TENNESSEE VALLEY AUTHORITY

By letter from D. B. Vassallo to H. G. Parris dated December 30, 1982, we received an NRC request for additional information concerning TVA Topical Report, "BWR Transient Analysis Model Utilizing the RETRAN Program," TVA-TR81-01. Enclosed is our response to that request.

ENCLOSURE
RESPONSE TO REQUEST FOR ADDITIONAL INFORMATION
BROWNS FERRY RETRAN
CPR METHODOLOGY (TVA-TR81-01)

FIGURE 1

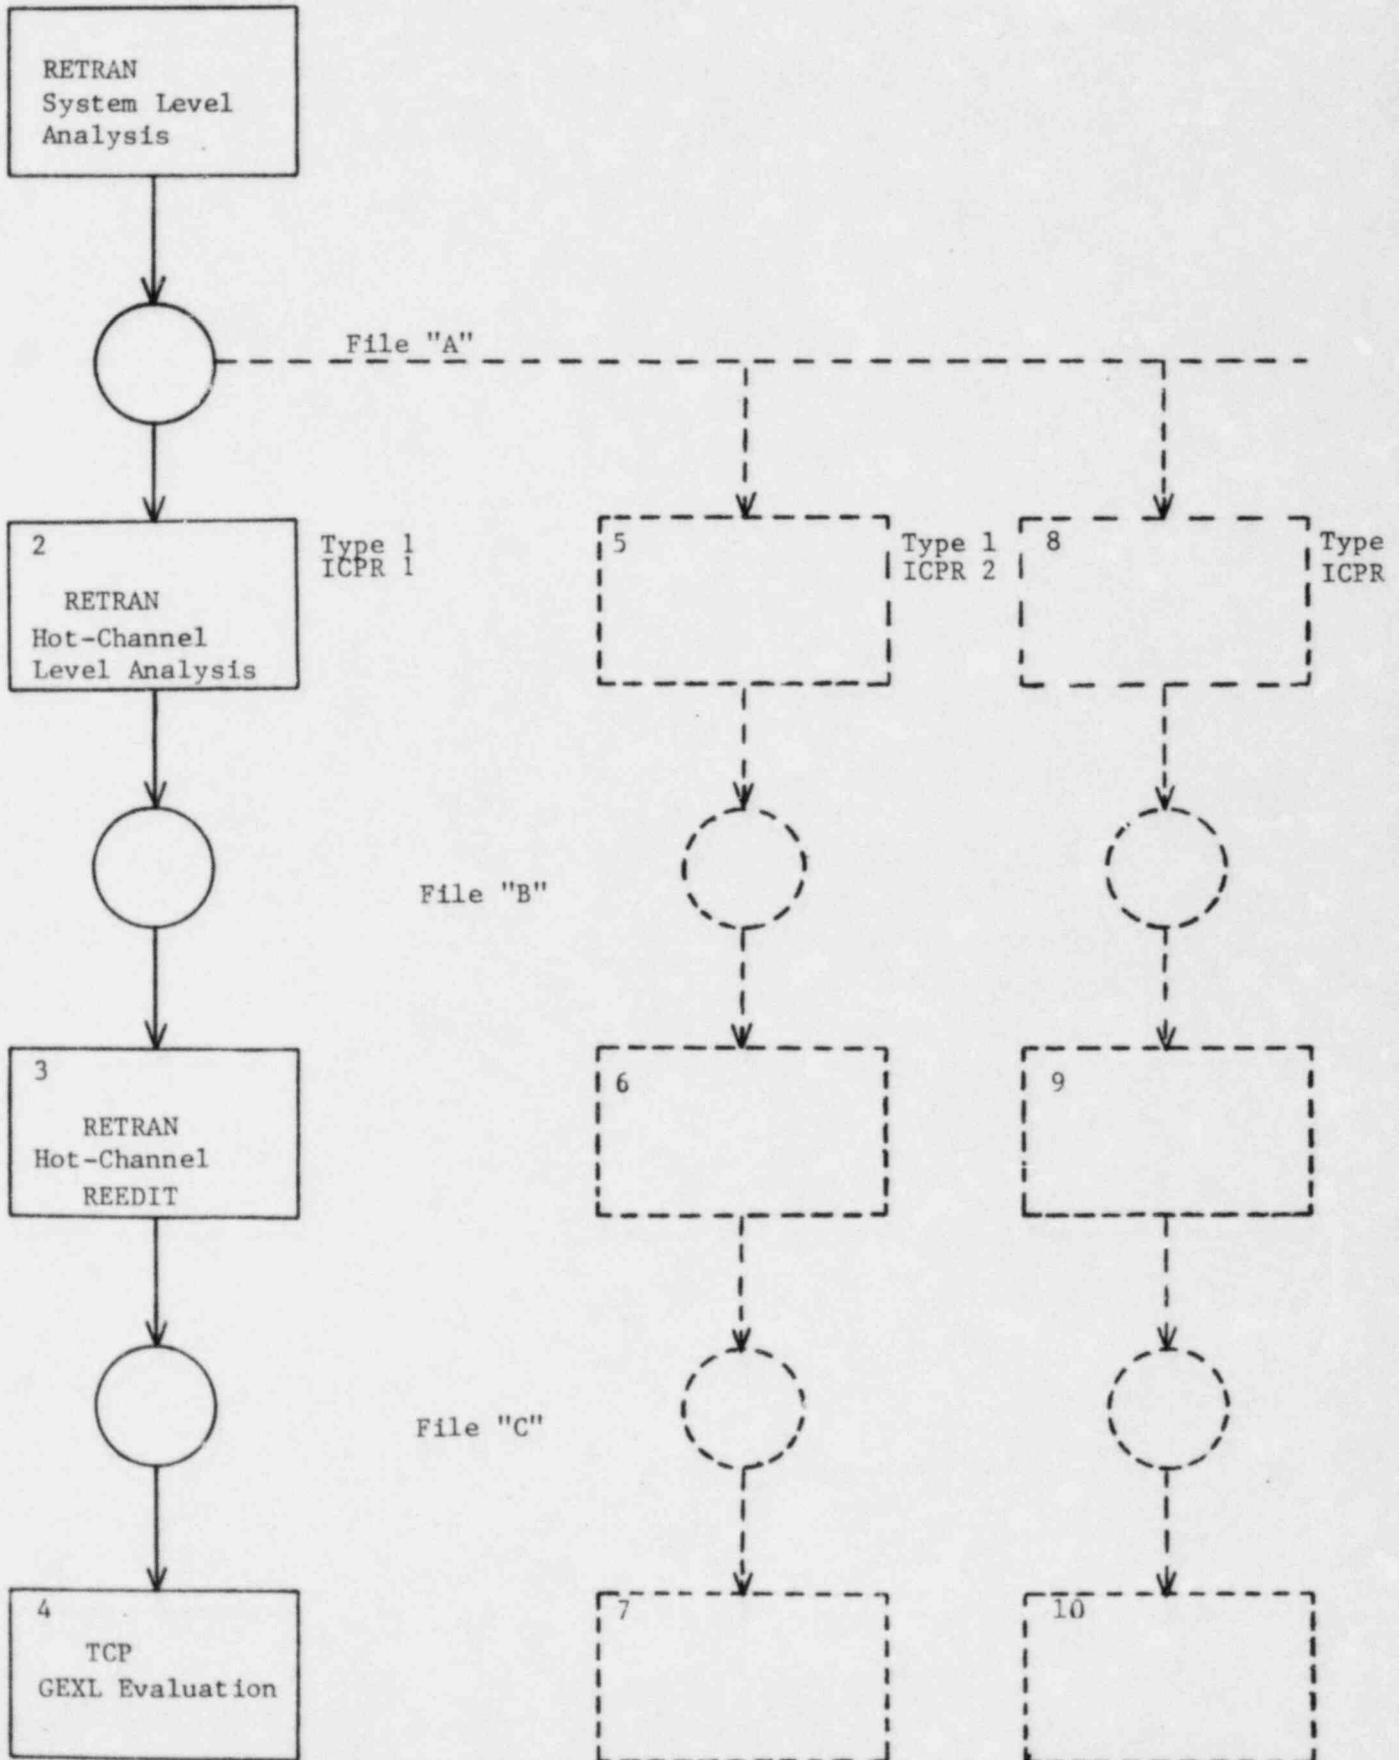
Q1. Since the RETRAN system transient analysis provides time-dependent boundary conditions for the RETRAN hot channel CPR calculation, how is the interface between the system analysis and hot channel CPR calculation accomplished? Is a separate RETRAN hot channel CPR calculation performed after the whole system transient analysis is completed? Provide a detailed description on how this is done.

A1. Figure 1 shows a schematic of the data flow for a transient critical power ratio calculation using the TVA methods. The complete system level calculation for an event is first performed (block 1) and a data file (labeled 'A') is produced (termed a data 'tape' in the RETRAN User's Manual). This file is of standard RETRAN format containing all of the T/H and neutronic solution results and can be utilized for restart calculations or, as in this case, to provide time-dependent boundary conditions to a RETRAN hot-channel analysis (block 2). For licensing calculations an approved generic design axial power distribution is always employed in the hot channel calculation.

The hot-channel level analysis also generates a data file (labeled 'B'). The data file produced by the hot channel analysis is read by the RETRAN 'REEDIT' option which produces a specially formatted output file (labeled 'C') containing the time variation of the junction flows and enthalpies in the hot bundle as well as the system pressure and associated enthalpies of saturated liquid and vapor.

The data file (termed an 'AUXILIARY DATA FILE' in the RETRAN User's Manual) produced by REEDIT and user input constants are all that are required to utilize the GEXL correlation to evaluate the transient CPR. The CPR evaluation is performed by a small auxiliary program TCP (block 4). The program TCPYA01 (reference 1) is functionally identical to the TVA TCP program from which it was derived and reference 1 describes the methods employed in TCP and shows comparisons to transient boiling transition tests.

The results of the TCP calculation are the initial channel minimum CPR (ICPR), the minimum CPR during the event (MCPR) and the maximum decrease in CPR ($\Delta\text{CPR} = \text{ICPR} - \text{MCPR}$). The initial power in the hot channel calculation is selected such that the MCPR is approximately equal to the 'safety limit' CPR (SLCPR) of 1.07. Sensitivity studies have shown that a change of 0.1 in ICPR generally results in less than a 0.02 change in ΔCPR so that the transient ΔCPR can be accurately evaluated if the ICPR is selected such that the MCPR is within 0.02 of the SLCPR. Normally, previous calculations allow the required initial hot channel power to be estimated closely enough that by running two hot channel cases differing by approximately 0.04 in ICPR, one of the cases will have an MCPR within 0.02 of the SLCPR. If this is not the case, the two results can be used to estimate a new hot channel power with the required MCPR and the hot channel-REEDIT-TCP calculation repeated. This procedure is utilized for each different fuel type (e.g., 8x8R, P8x8R) in the reactor core.

Each of the blocks on figure 1 represents a separate program execution and can be performed separately. However, the normal practice is to perform the calculations as successive steps in a single computer job.
